Re: Minor Subdivision Application of Anatoliy & Leonid Klimenko
TMP No.: 26-001-090
84 Curley Mill Road, New Britain Township, Bucks County

Re: Minor Subdivision Preliminary Plan
84 Curley Mill Road, T.M.P. #26-001-090
Prepared by R.L. Showalter & Associates, Inc., dated May 30, 2023

Reference: Klimenko Minor Subdivision Plan – Preliminary Plan Review 1
84 Curley Mill Road, TMP #26-001-090

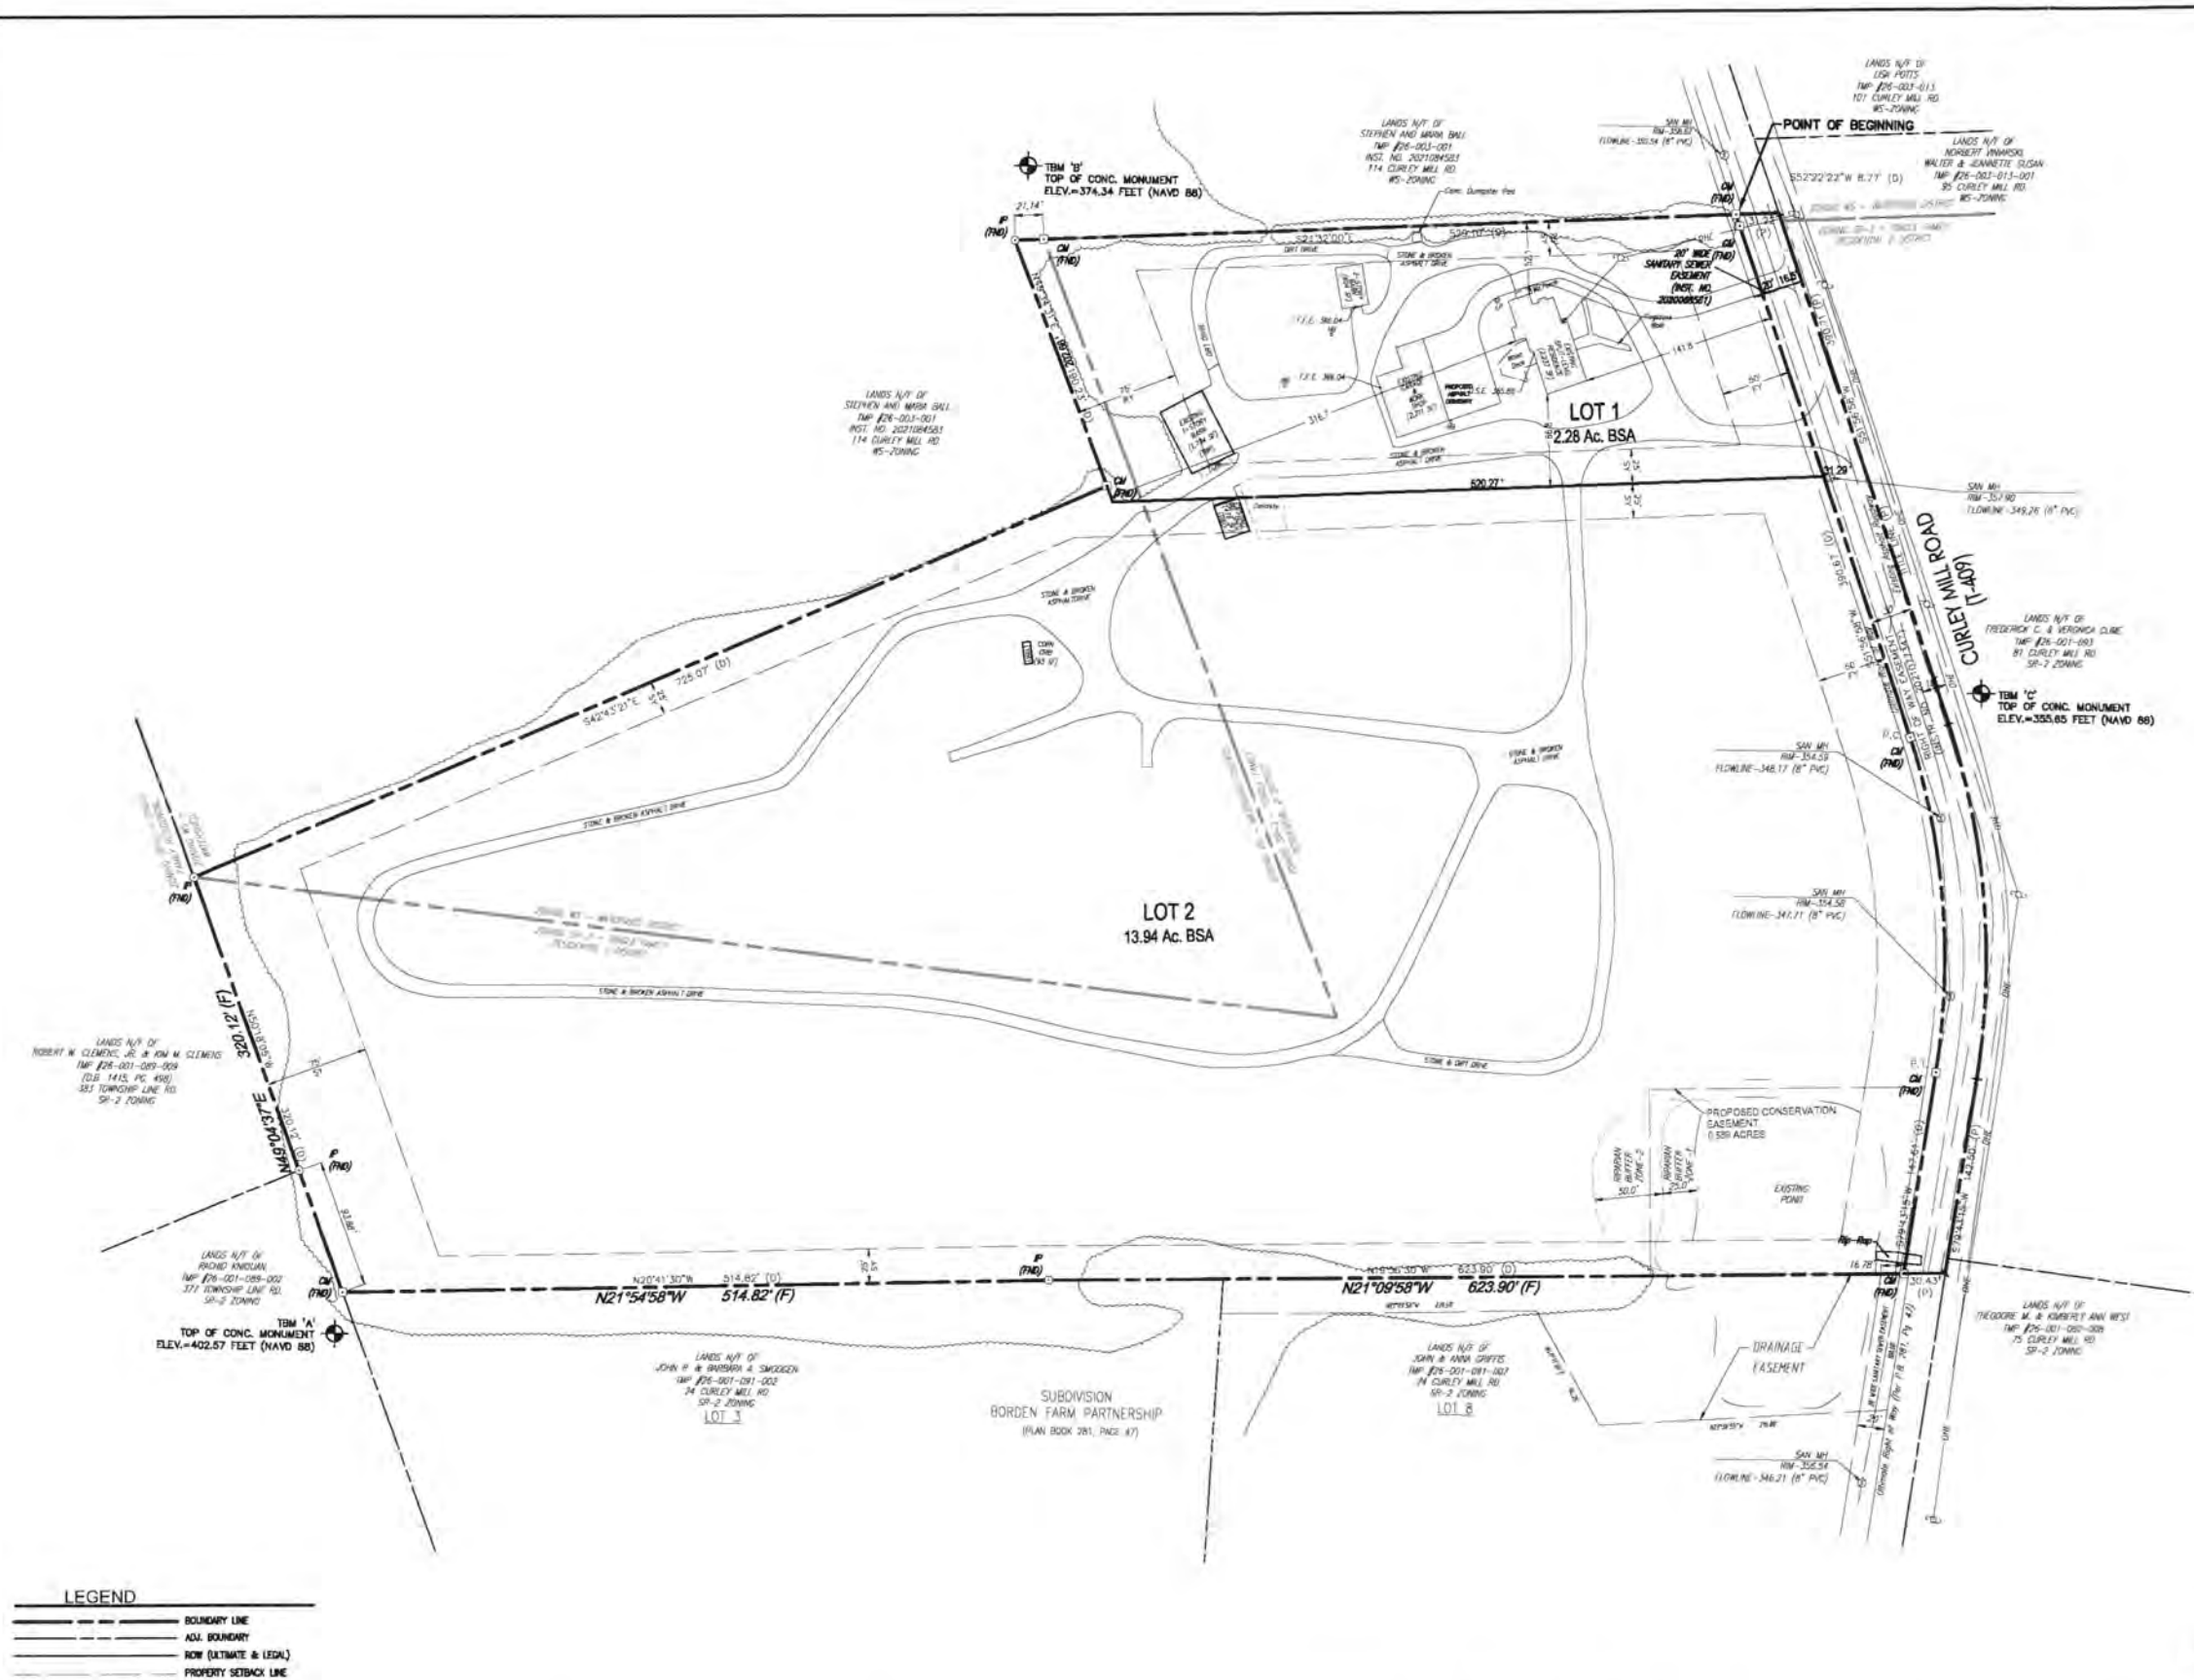
1. Please clarify if a rezoning of the subject properties is associated with this project.
2. Please show if there are any proposed natural resource easements, as per ZO Section 27-2402.c.

1. §27-107 – Sheet 1 is entitled Minor Subdivision and Re-Zoning Plan, however, no areas of the subject tract are proposed to be re-zoned. Any references to Re-Zoning should be removed and any proposed zoning changes shall be reviewed under separate application. Changes of any nature to the Official Zoning Map are required to be in conformity with the amendment procedures set forth in the Zoning Ordinance. We recommend a staff meeting to discuss any changes in zoning prior to presenting the plans to the Board of Supervisors.

2. §27-501 & §27-801 – The proposed use for Lot 2 shall be clarified, as the plans currently note an existing and proposed use as B1 – Single Family Detached Dwelling, yet no improvements are shown for Lot 2.

3. §§27-502.b.1(d) – The side yard setback of Lot 2 within the WS Watershed District shall be increased to the required 30 feet, unless the area is approved to be re-zoned under separate application. Similarly, the rear yard setback for Lot 1 can be revised to 60 feet.

4. §27-502.b.1(h) & §27-802.b – We offer the following comments in regard to the impervious surface coverage shown on the plans:
 - a. The existing asphalt noted in the Impervious Surface Summary Table for the Existing Lot, Lot 1, and Lot 2 do not correspond with the areas shown in plan view and shall be confirmed. Per §27-201, impervious surfaces shall include all areas that do not absorb water. Due to the nature of the site, all areas of compacted dirt driveways shall be included in the impervious calculations.

- b. The Impervious Surface Summary Table notes that no new impervious surface is proposed on Lot 1, however, the plan view shows a proposed driveway. The areas shall be verified.

- c. Once the impervious surface areas are verified, the maximum impervious coverage for the Lots and Site shall be confirmed. We also note that the Total Proposed percentages in the Impervious Surface Summary table for the Maximum Building Coverage and the Maximum impervious Coverage for the site do not correspond with our measurements from the plan view or in the table and should also be verified.

- d. All impervious areas to be removed shall be hidden from the proposed plan view on Sheet 1.
5. §27-2400.g – The Natural Resource Calculation chart shall be revised to include all areas of naturally occurring steep slopes as shown on the plans.

6. §27-2401.c – The plan proposes a conservation easement over the existing pond and portion of riparian buffer. The easement shall be revised to protect 100% of the riparian buffer in accordance with this section. The Declaration of Easements shall be prepared by the Township Solicitor.

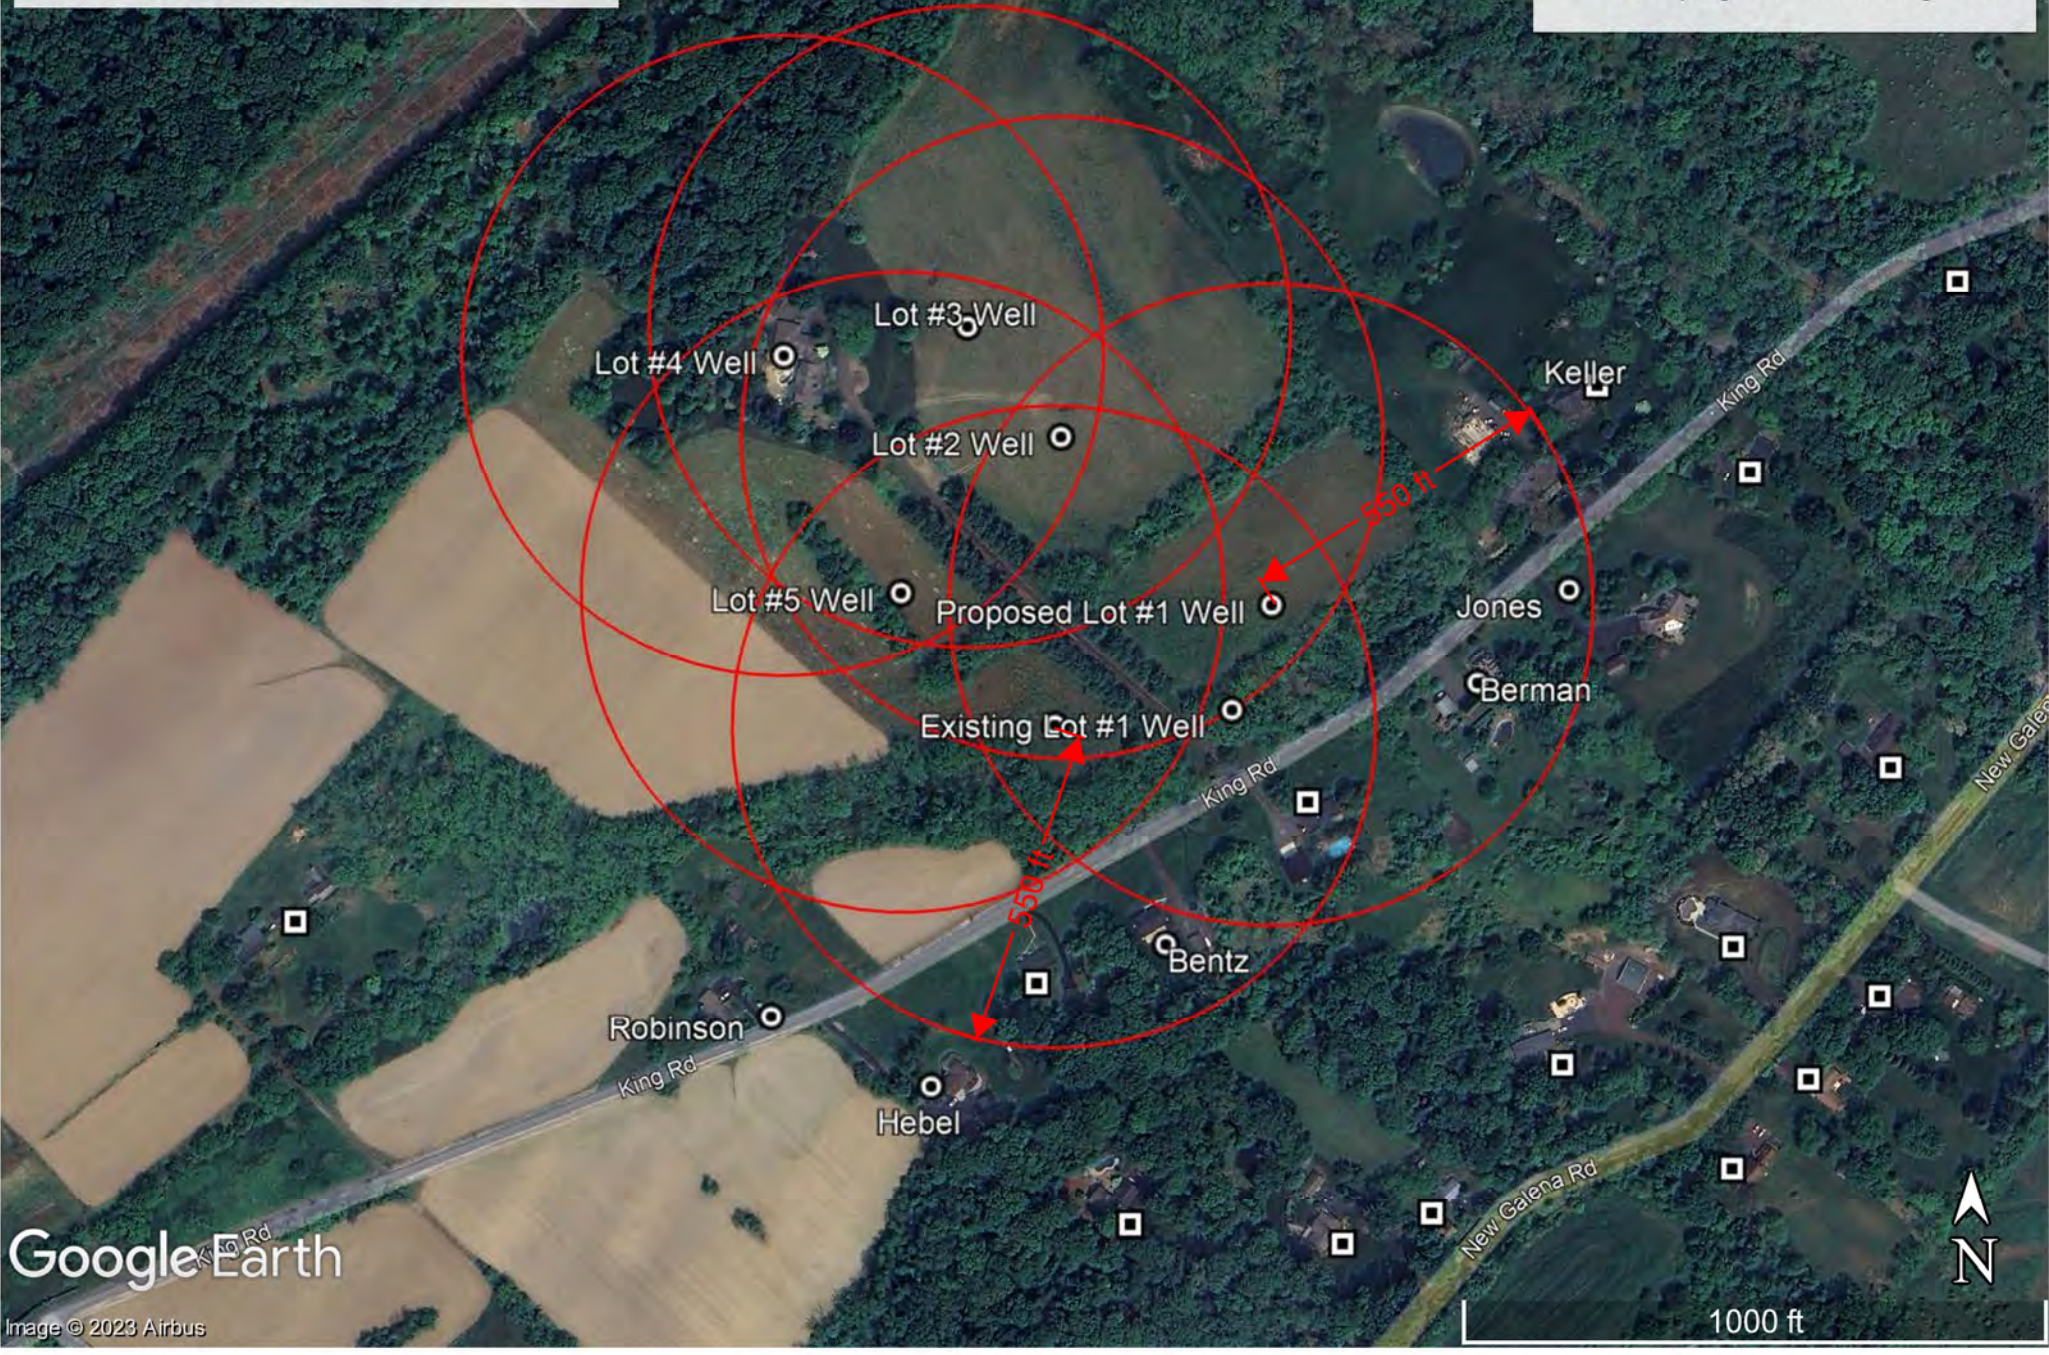
4. The report shall include a contour map of water levels in the test well and monitoring wells after one year of pumping under drought conditions (no recharge), based upon the pump test data (§719.8.E.7). The contours in Figure 7 of the report do not reflect the water levels from the pump test data.

The contours in Figure 7 of the report reflect the water levels from the pump test data after 1 year of pumping, as they were plotted directly from the projected ground water elevations shown on Table 4. The ground water elevation after 1 year of pumping the Lot #2 well could not be plotted because the projected drawdown at the excessively high rate of the pumping test without recharge exceeded the depth of the well. Since the Lot #2 well was re-hydrofracked, the constant rate portion of the 2-part pumping test on the well showed that the sustainable pumping rate from the well exceeded that of the long-term pumping test.
